CAMPBELL COUNTY PLANNING COMMISSION MEETING AGENDA

RESUBDIVISION OF LOTS 1 & 2, RTFO SUBDIVISION

**Resubdivision of Lots 1 & 2, RTFO Subdivision
To be known as
Lots 1A, 1B, 1C & 2A, RTFO Subdivision**

Case Number: 20.01 COMP

FINAL PLAT
 SHEET 1 OF 1

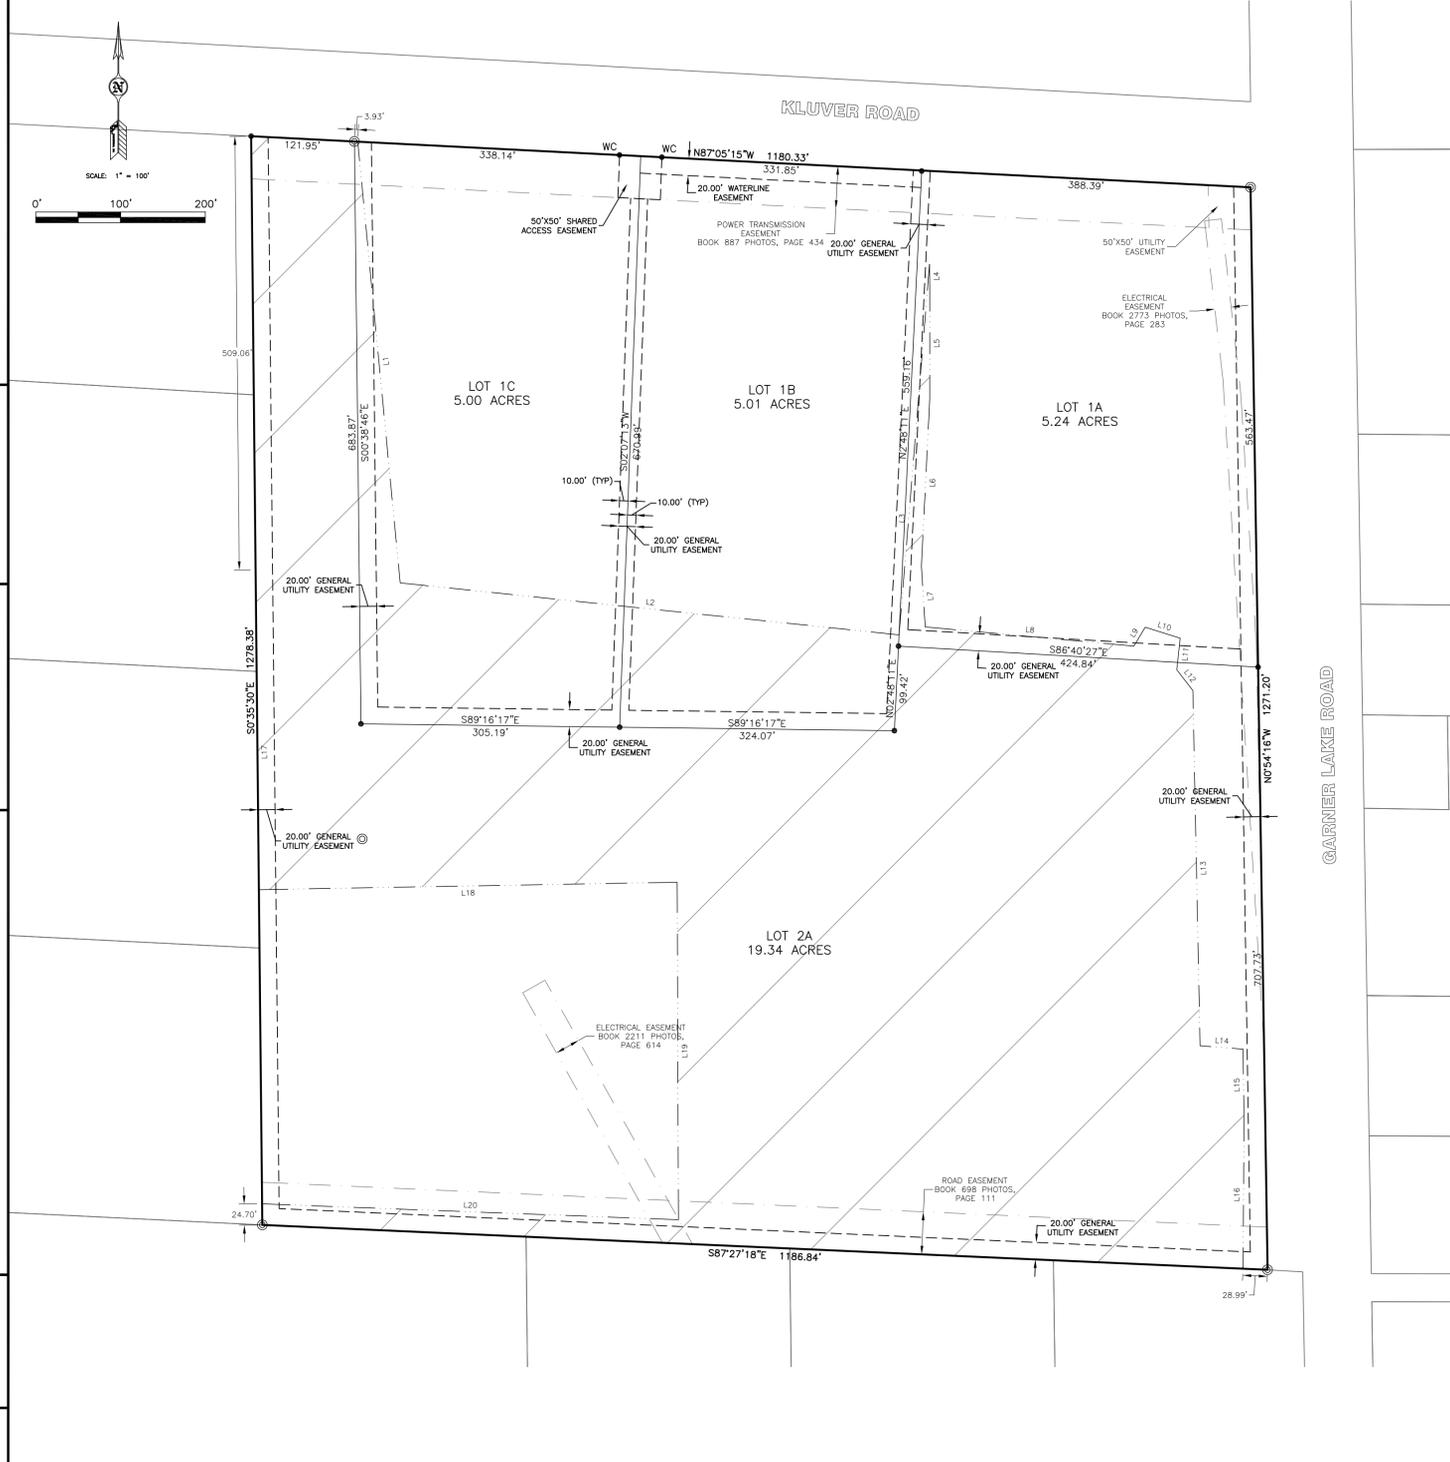
9. Cosmetic Plat Revisions:
 - a. Re-number Lots 1A-1C from left to right on the plat face
 - b. Add the statement NO CENTRALIZED WATER SYSTEM
 - c. In the legend it references "proposed easement". Remove proposed and show only easements as they will exist now on the plat.

10. Survey Review:
 - a. All dimensions (distances, directions, and curve data) of all parcels surveyed or created shall be shown as horizontal distances at ground surface in feet.
